Revision 3 to Transnuclear, Inc. (TN) Application for Amendment 10 to the

Standardized NUHOMS[®] System (Docket No. 72-1004; TAC NO. L24052)

Letter from B. Jennifer Davis (NRC) to Donis Shaw (TN), "SECOND REQUEST

FOR ADDITIONAL INFORMATION FOR REVIEW OF AMENDMENT 10 TO THE STANDARDIZED NUHOMS® SYSTEM (TAC NO. L24052), INCLUDING

Figure 3-1-1: Comparison between the Irradiated and Unirradiated Materials (Tensile Strength and Displacement as a Function of Hydrogen Concentration)

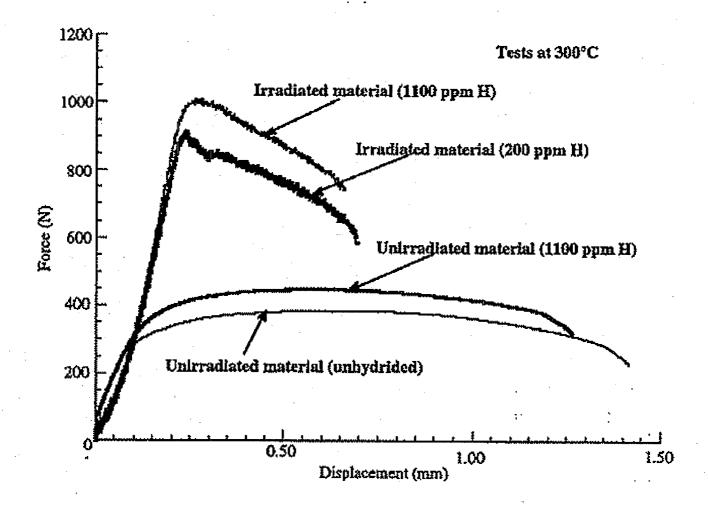
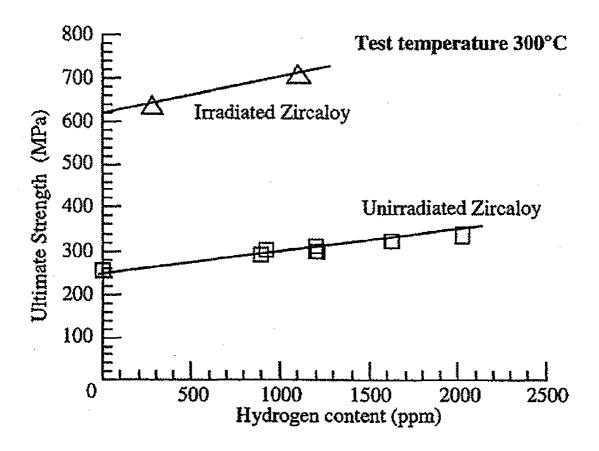
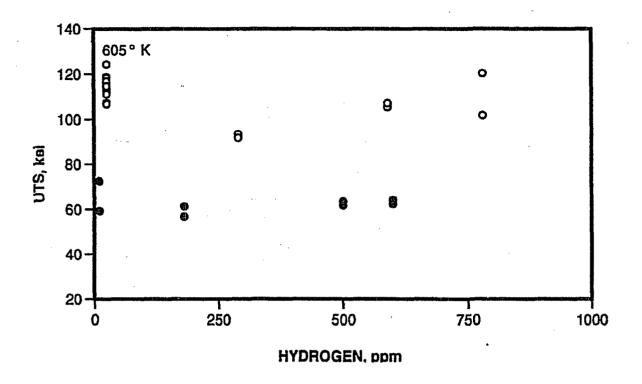
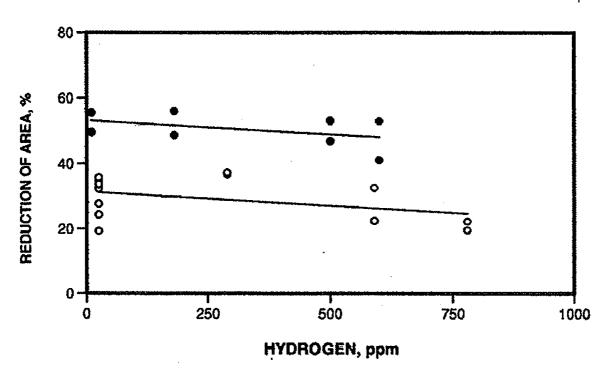
3-1: With respect to your response to RAI 3-4 (Round 1), please provide justification for the assumption that the mechanical properties of unirradiated Zircaloy with radial hydrides represent the behavior of high burn-up irradiated Zircaloy-2 with radial hydrides.

In addition, it is also important to point out that based on the results shown on the response to RAI # 1, Question 3-4 [3-1-4] the maximum calculated hoop stress is 24,312 psi. This calculated stress, when compared with the reduced cladding yield strength (20% reduction), still shows a factor of safety of 2.43. The uncertainty of the yield strength of the cladding due to the effect of radial hydrides can be easily accommodated with this large margin of safety.

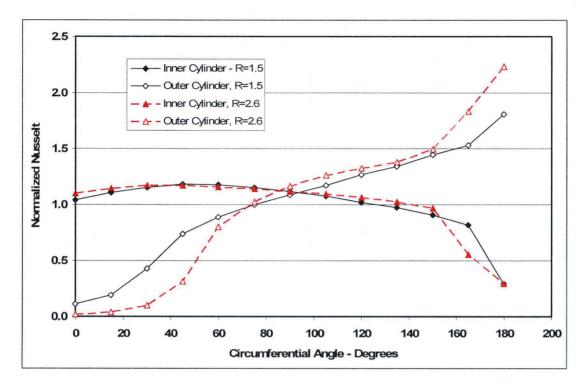
4-5: Provide a discussion of how a circumferentially varying Nusselt number in the liquid neutron shield annulus would effect the temperature distribution of the DSC within the OS-200 TC. Include a discussion of the effects of the stagnation zone at the bottom of the liquid neutron shield annulus. A discussion of the limitations associated with the constant Nusselt number approach, as presented in Section U.4.5.2 and U.4.2 of the SAR, should also be included.

Based on these trend lines, it is concluded that the trend lines in Figure 14 can be used to estimate the variation in the Nusselt number with angle for this application. For conservatism, the trend lines for R=2.6 are used to conservatively bound the gradient in heat transfer rates on the outer cylinder. The data points in the figure above are used to convert the average k-effective values presented in Table 4-14 of the NUHOMS® HD FSAR to local values as a function of angle and position in the neutron shield. Since the thermal modeling for the OS200 TC neutron shield sub-divides the shield into 3 elements in the radial direction and at every 15° around the circumference, the approach is to use the variation along the inner cylinder (i.e., the structural shell of the TC) vs. the angle for the inside set of elements, the variation along the outer cylinder (i.e., the shell of the neutron shield) for the outside set of elements, and the average of the two for the center set of elements used in modeling the shield. The effect is to vary the k-eff from approximately 112% of the average at the bottom, inside of the neutron shield to approximately 43% of the average at the top, inside of the shield and from approximately 203% of the average at the top, outside of the shield to 4% of the average (i.e., pure conduction/stagnation) at the bottom, outside of the shield.

Figure U.4-11
HSM-H Component Temperature Distributions for
Blocked Vents Accident Storage Condition @ 35 hr, DSC with 40.8 kW, 117°F Ambient

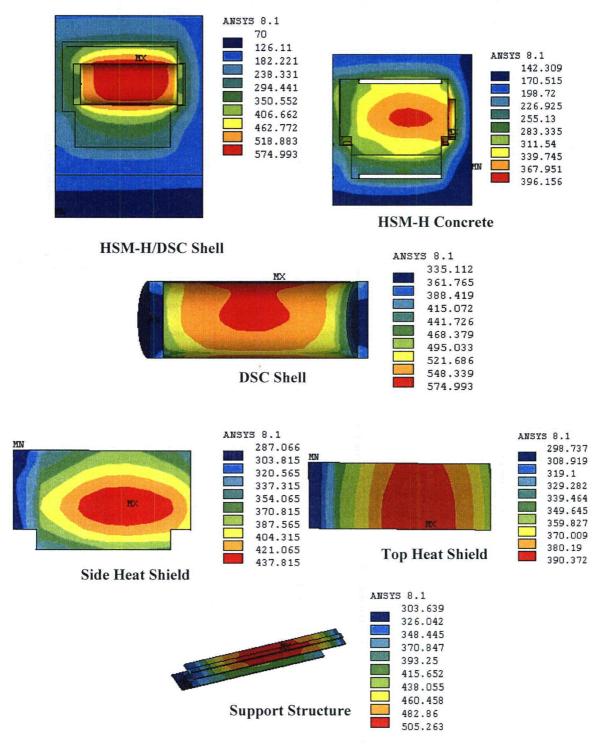
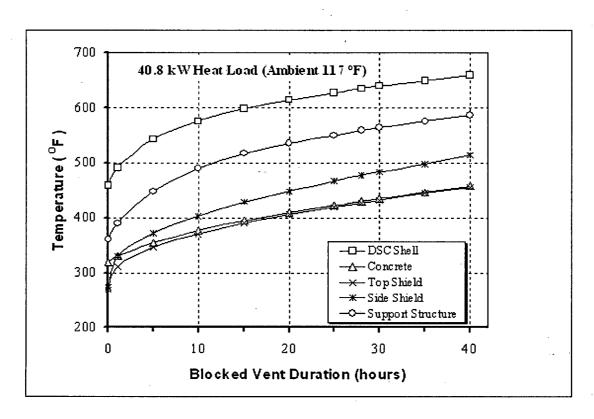
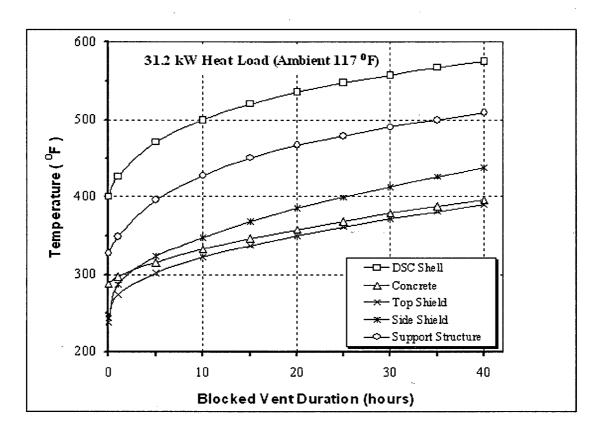
4-12: Clarify the phrase: "7.9" No Convection Zone," which appears in Figures U.4-11 and U.4-13 for the Blocked Vent accident condition transient.

Captions for Figures U.4-11 thru U.4-13 include the added phrase "7.9" No Convection Zone." Given that the blocked vents accident neglects convection (i.e., conduction only to cavity air) within HSM-H, according to SAR text (see Section U.4.4.5 – Description of

The evaluations in Amendment 10 SAR, Rev. 1 account for a "dead zone" of 18.9° for the normal and off-normal analyses of an HSM-H with a 32PTH1 DSC. Since the initial conditions for the blocked vent transient analysis are based on off-normal conditions, the maximum temperatures for the blocked vent accident conditions were also affected by increasing the dead zone angle to 18.9°. This change resulted in corrections in Rev. 1 of Table U.4-3, Table U.4-24 through Table U.4-26, and Figure U.4-10. Since the temperature distributions for HSM-H components except for the DSC shell are similar before and after the correction of the dead zone angle, the temperature distributions and the time histories in Figure U.4-11 through Figure U.4-14 do not include new information and are not updated. The intention of the phrase "7.9° No Convection Zone" is to indicate that the content of the corresponding figures is not updated. This phrase is revised in Revision 3 of Amendment 10 to clarify the intention.
